# Access Compliance Report

## Public Rights-of-Way

| Intersection ID: 12157                  | Main Street: MIDLAND_AV | Cross Street: AMERIGO_ST                | Location: NW           |
| ADA ID: 57C10E658D58                    | Ramp Type: Perp         | Initial Pass/Fail: Fail                 | Overall Compliance: No |

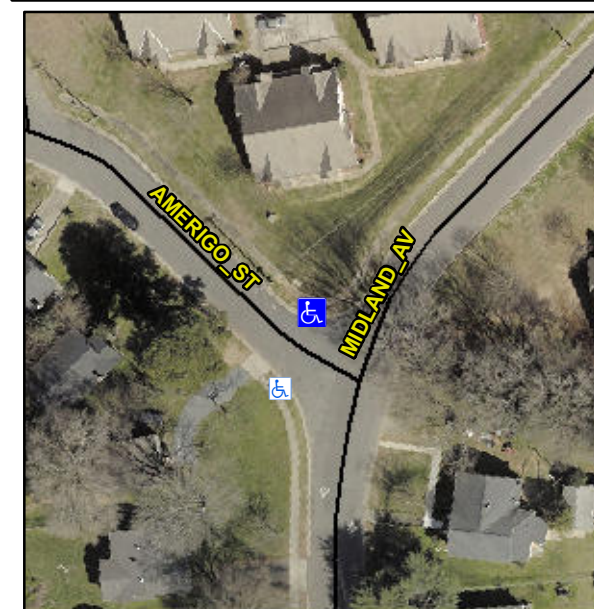
**R304.5.1, R304.5.3**

| Compliance | Description           | Data | Compliance | Description                 | Data |
|------------|-----------------------|------|------------|-----------------------------|------|
| No         | Ramp Width (in)       | 39.5 | No         | Ramp XSlope (%)             | 4.8  |

**Remove & Replace Entire Ramp.**
